PREPARED FOR THE URBAN DESIGN COMMISSION AND PLAN COMMISSION

Project Address: 126 South Carroll Street
Application Type: Rezoning
Legistar File ID # [37800](#)
Prepared By: Heather Stouder, AICP, Planning Division
Report Includes Comments from other City Agencies, as noted

Requested Action: Approval of a rezoning from PD-SIP to Amended PD-SIP for the construction of a nine-story mixed-use building with 5,900 square feet of commercial space and 88 residential units.

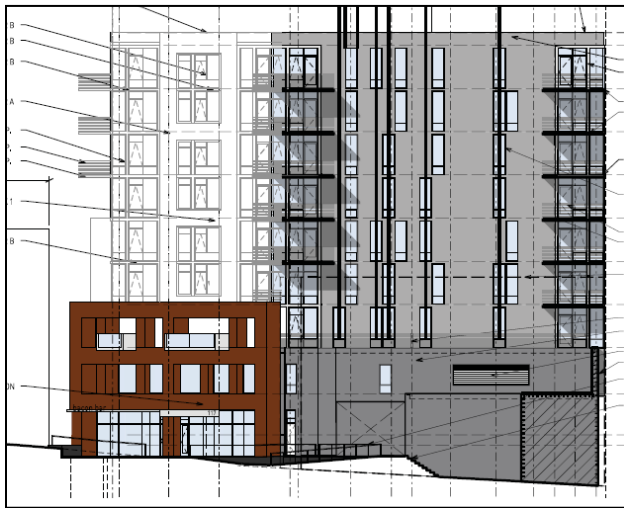
However, the proximity of the proposed building to these property lines corresponds with a building code limitation for the percentage of window openings on these two facades. In a revised version of the plans (submitted and reviewed by the Landmarks Commission), the design is much more compatible with the other facades on the building, and staff appreciates the significant improvement over the originally submitted elevations (see comparison below).

Due to the proximity of the facades to the respective property lines, many of the window panels on these two facades are false - opaque spandrel glass in front of walls and columns. The UDC should pay special attention to the detail for the proposed spandrel to ensure that it will read as a window, particularly from the long views toward these facades from both the Capitol Building and from the bottom of the hill on South Hamilton Street.

Proposed Carroll Street Encroachment

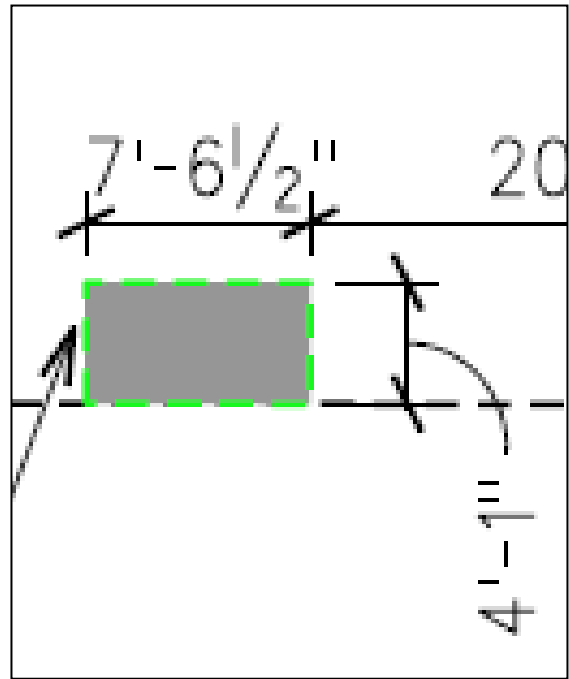
As mentioned on page 3 of this report, the applicant is requesting approval for an encroachment into South Carroll Street for balconies associated with dwelling units at the corner of West Doty and South Carroll Street (see rendering and encroachment exhibit below). As mentioned in Condition No. 25, the request must be approved separately as a privilege in streets agreement, and may not be approved as part of this request. As with the similar balconies shown on other sides of the building, staff would prefer that the balconies be placed on private property, within an inset of the building.

Beyond the encroachment issue alone, staff would like for the UDC to carefully review the similar balconies shown on the building exterior on other sides of the building. Staff believes that these could be improved if adjustments were made to inset, or at least partially inset the balconies.
